Seattle
Design
Commission

MINUTES OF THE MEETING

1st December 2005

Projects Reviewed

Four alternatives are in consideration

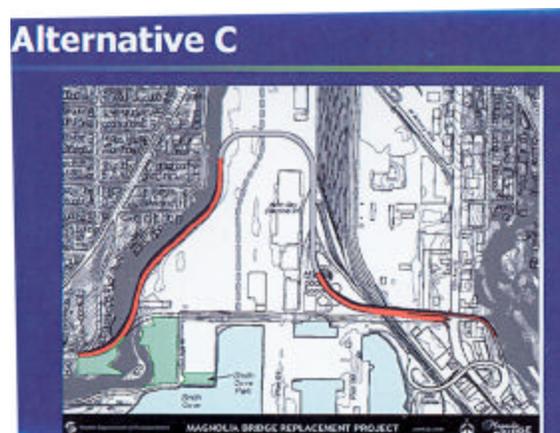
- **supports and favors Alternative C, with a 7:1 vote, followed by Alternative D. Alternative A is less favored, and the Rehabilitation Alternative is not liked at all.**

- **believes that the present climate of fear and safety should not override long-term design decisions.**
- **considers both Alternatives C and D to provide the potential for good pedestrian and bike access to the water, and opportunities for urban design development at the ground level, which is why they find them more desirable.**

- Asks which the proponents prefer.
 - A and D
 - Both are functionally the same
 - From an urban design perspective D because
 1. Pulls away from the water and complies with the shoreline policies

- Alternative C puts a road through the middle of this
- Suggests that if C is not an option, need to consider a bridge that is not an eyesore.
- Would like to see the bridge skirt the water's edge, in order to reveal the unique qualities of Seattle's working waterfront.

- Feels it would be inappropriate to support A, considering the current proposals to remove the viaduct downtown.
- Confirms that D pulls away from the water and creates potential opportunity for public access.

- Recommends alternative C because this has the least impact and affords the most opportunities.
 - Resistance from the Port because it inhibits their plans

- Has consensus to recommend alternative C, followed by D, reluctantly A, but not the rehabilitation alternative.

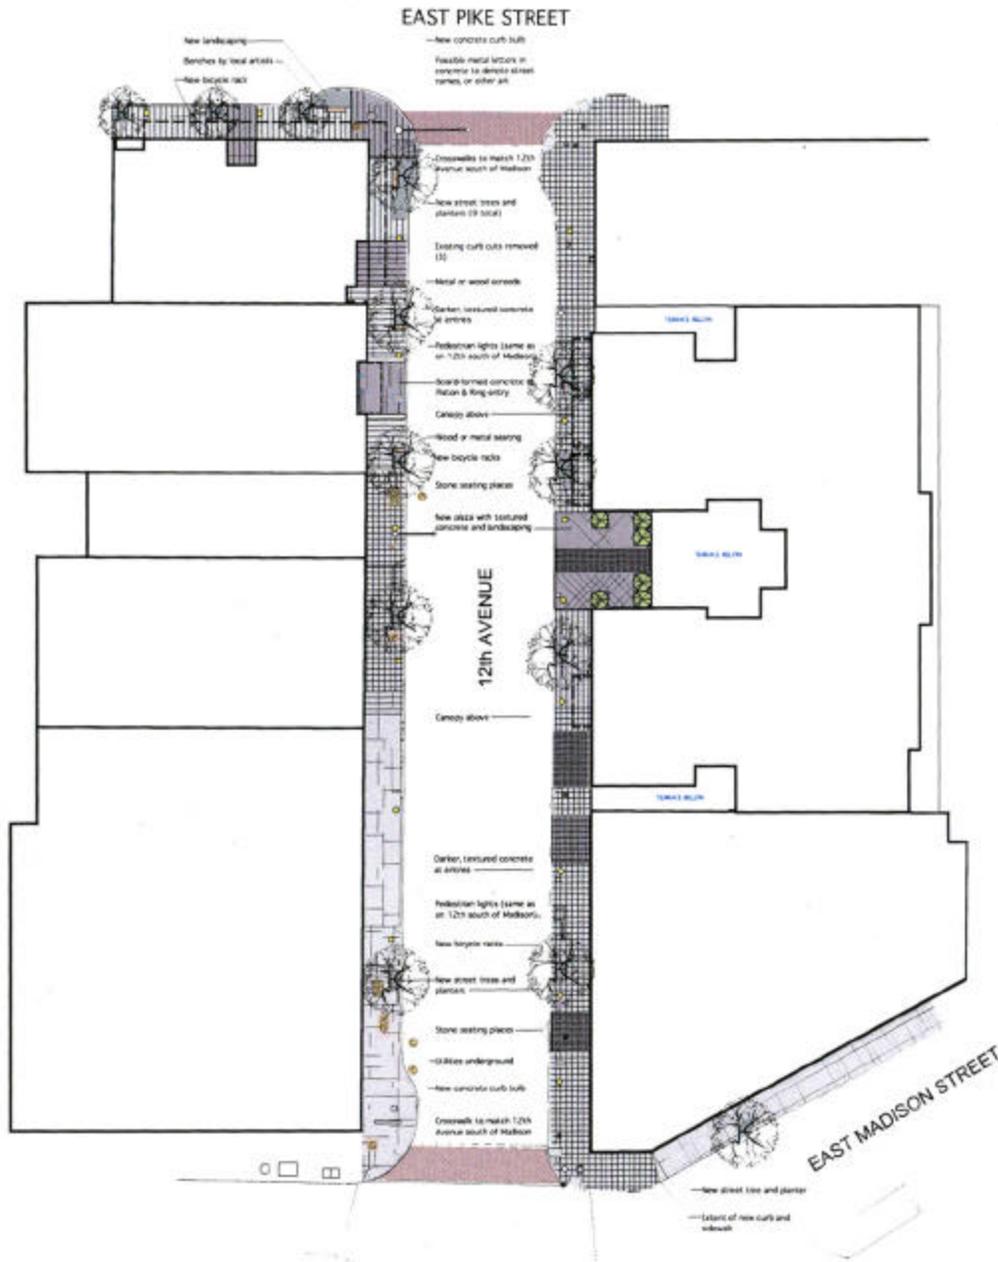
- **recommends that SDOT approve the sidewalk design features being proposed by the developers, subject to the following comments and concerns.**
- **would like to commend the property developers for their significant efforts to improve the streetscape and to reduce the clutter of overhead utilities and utility poles.**
- **is generally in favor of the sanctity of the public sidewalk, but in this case, supports the special design features since they are sympathetic and complementary to SDOT's own street specifications and recent 12th Avenue streetscape improvements.**
- **stop short of endorsing the wood plank stamped concrete and have some concern about "do or matting" all the building entries.**
- **supports the artwork and street furniture, such as custom bike racks, benches and seating areas, provided that more detail is forthcoming.**

- Recommends a planned attitude to the art work, rather than a piecemeal approach.
- Suggests referencing the SDOT art plan.
- Questions the limited number of trees
 - Restricted by buried City Light power lines
- Recognizes and encourages the voluntary commitment from businesses
- Appreciates the voluntary nature of the improvements, but is concerned that the treatment to the concrete sidewalk, at business entrances, will resemble doormats. Worries that this element is self serving.
- Encourages continuity in the public streetscape.
- Feels it is important to uphold the public domain of the sidewalk.
- Thinks paving applications add richness to the urban fabric .
- Does not support the application of a wood plank texture.

Aurora Tomorrow

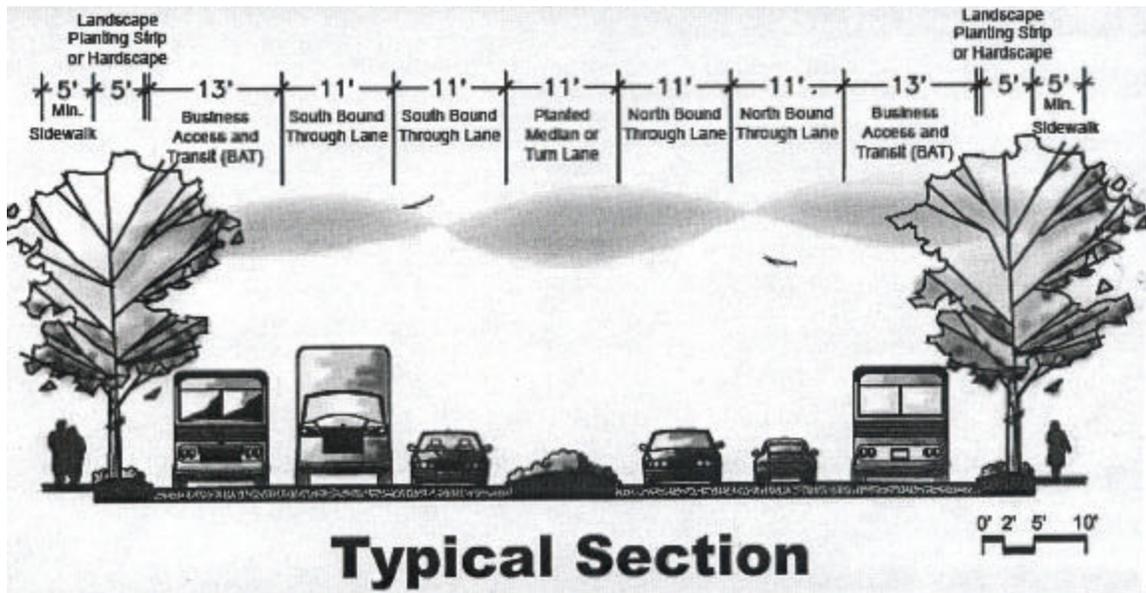
- encourage proponents to consider extending the strips of alternating landscape and hardscape to promote a sense of continuity and less of a jagged edge.

- urge the use of big trees wherever possible considering the scale of Aurora, and where this is not possible, they recommend tightening the spaces between trees to create more of a cluster.

- Encourages proponents to simplify the pattern of planting strips. Suggests that blocks should either be paved or landscaped rather than alternate 6' strips.

- Advocates for large trees where ever possible , owing to the scale of the street. Where this is not practical, suggests closer spacing.
